FCC ID: H9PLA3021-100 Class II Permissive Change

RE: Letter of Changes – Class II Permissive Change
FCC ID: H9PLA3021-100

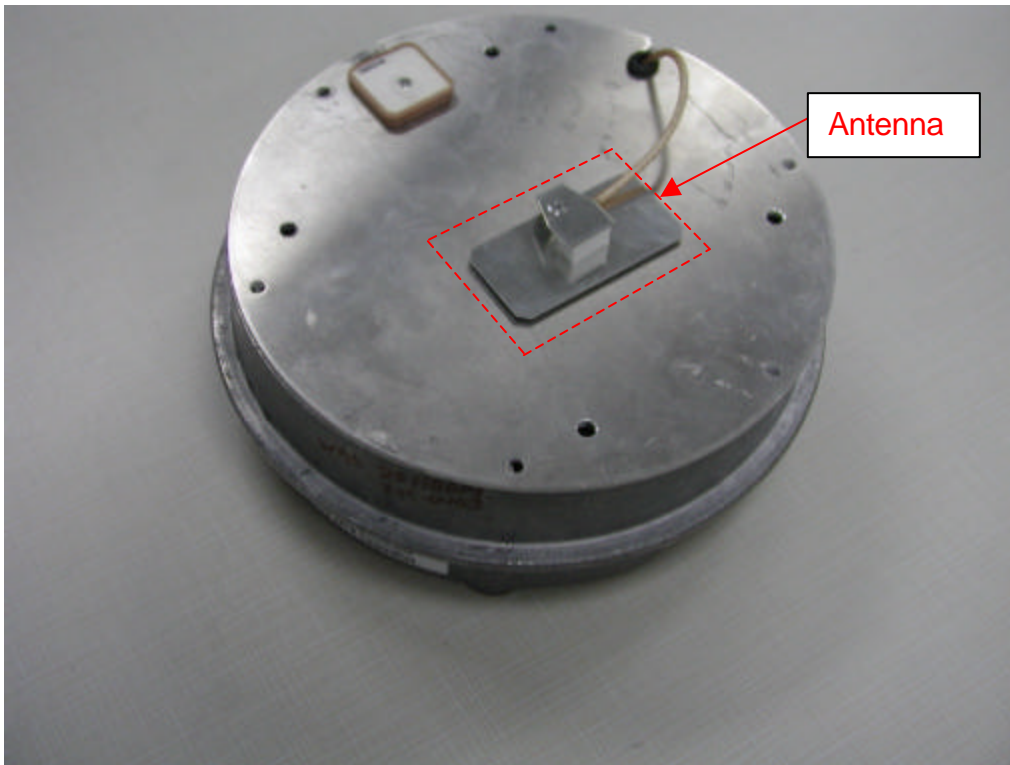
The change being requested under the original application for the Symbol LA-3021-100-US radio is the addition of the Folded F antenna from Maxrad. The Maxrad part number is Z1370 with the following specifications;

Frequency range 2.4 – 2.485 GHz

Gain 3 dBi

The following picture shows the placement of the Folded F antenna on the enclosure

This module is permanently mounted on the outside of the truck and away from the driver or other occupants.
